Technical News

Issue 154

Description: Excessive Top End Engine Noise - Valve Guides and Camshaft Chain Tensioner
Models affected: Trophy and Trophy SE

1. Oil restrictor and O-ring

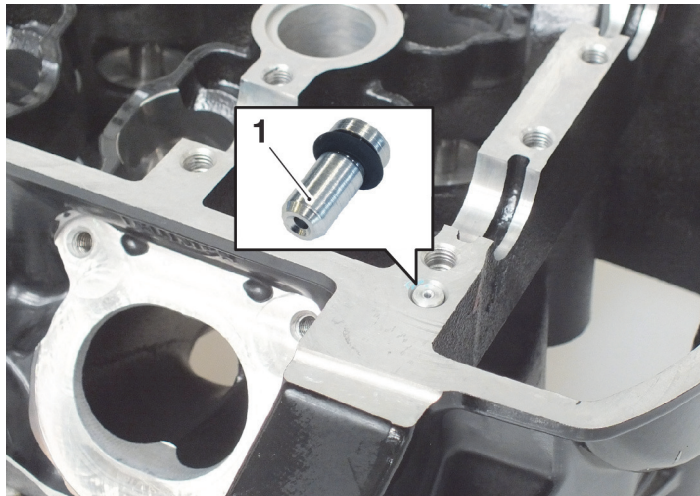
-
4. Fit the O-ring to the cylinder head oil restrictor (both are supplied in the kit) and fit the oil restrictor to the new cylinder head.

- 1. Camshaft**
2. Threads

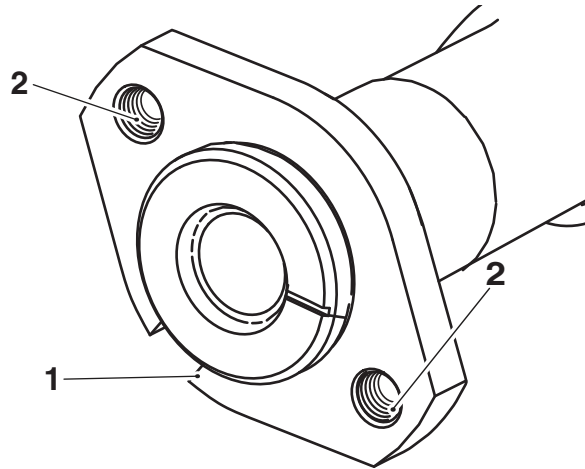
Failure to clean the threads of the camshafts could cause the camshaft boss to crack during the tightening sequence. Always clean the threads as described above and install new bolts during assembly.

5. Using an M7 x 1 mm tap or other suitable tool, clean the threads of the inlet and exhaust camshafts.

1. Copper washers

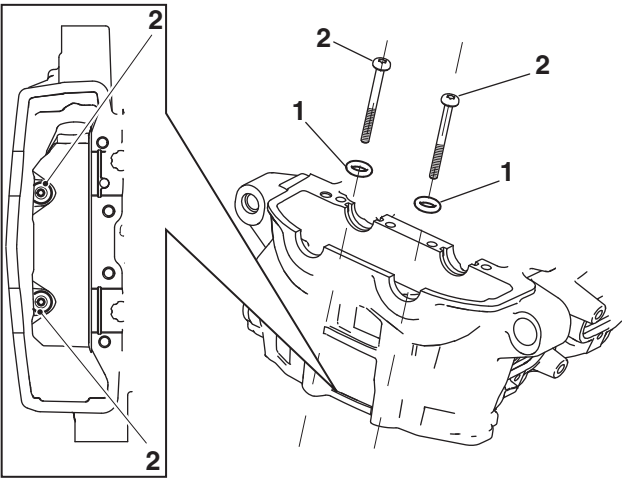
6. Install the cylinder head using the parts supplied in the spares kit, as described in the Service Manual, noting the following:
7. **Models up to VIN 584030:** Fit the copper washers to the right hand outer cylinder head screws.
